# Sladden Engineering

Project No. 644-20039

Project: Proposed Industrial/Warehouse Buildings  
APN 314-091-005  
Seaton Avenue  
Perris Area  
Riverside County, California

Ref: Geotechnical Investigation report prepared by Sladden Engineering dated December 23, 2020; Project No. 644-20039, Report No. 20-12-093

Title: OVERALL SITE PLAN

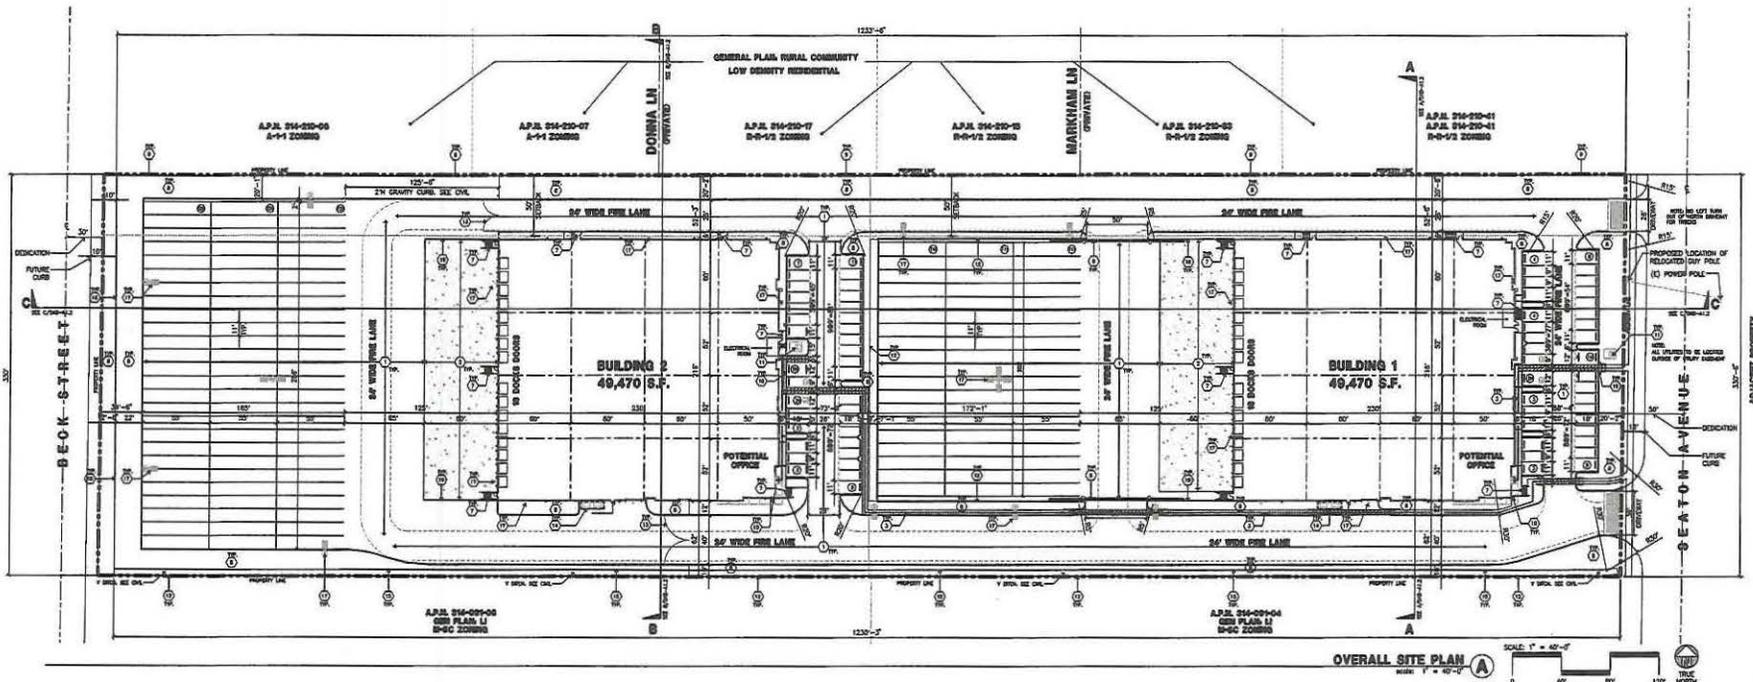
In accordance with your request, we have reviewed the most recent development plans for the subject property (APN 314-091-005) located between Seaton Avenue and Beck Street just north of Perry Street in the Perris area of Riverside County, California. The current plans (attached) indicate two industrial/warehouse buildings in lieu of the single industrial/warehouse building indicated on the initial plans. The proposed development, grading and building construction type remain consistent with the assumptions considered in the development of the recommendations provided within the above referenced report. It is our opinion that the recommendations provided within the referenced Geotechnical Investigation report remain applicable for use in the design and construction of the currently proposed project.
